<b>Title of Change:</b>	Schottky Metallization Change And Lead Frame Modification for SOD 123 FL Package
<b>Proposed Changed Material First Ship Date:</b>	02 Oct 2023 or earlier if approved by customer
<b>Current Material Last Order Date:</b>	N/A <i>Orders received after the Current Material Last Order Date expiration are to be considered as orders for new changed material as described in this PCN. Orders for current (unchanged) material after this date will be per mutual agreement and current material inventory availability.</i>
<b>Current Material Last Delivery Date:</b>	N/A <i>The Current Material Last Delivery Date may be subject to change based on build and depletion of the current (unchanged) material inventory</i>
<b>Product Category:</b>	Active components – Discrete components
<b>Contact information:</b>	Contact your local onsemi Sales Office or SitiNurhaza.MohdRamli@onsemi.com
<b>PCN Samples Contact:</b>	Contact your local onsemi Sales Office to place sample order. Sample requests are to be submitted no later than 45 days after publication of this change notification. Samples delivery timing will be subject to request date, sample quantity and special customer packing/labe

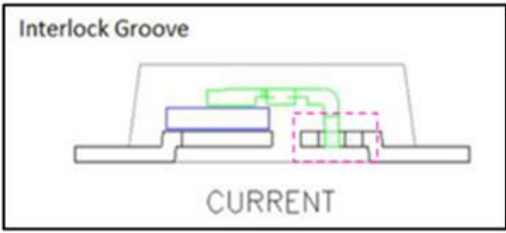
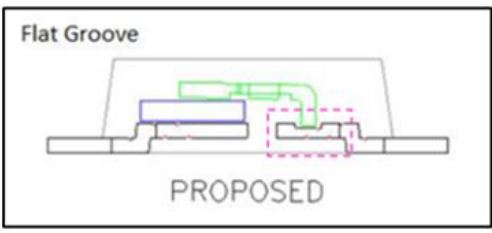
From	To
<b>Top metalization</b>	TiW/NiV/Au	TiW/NiV/Ag
<b>Back Metalization</b>	Cr/Ni/Au	Ti/Ni/Ag
<b>Leadframe</b>
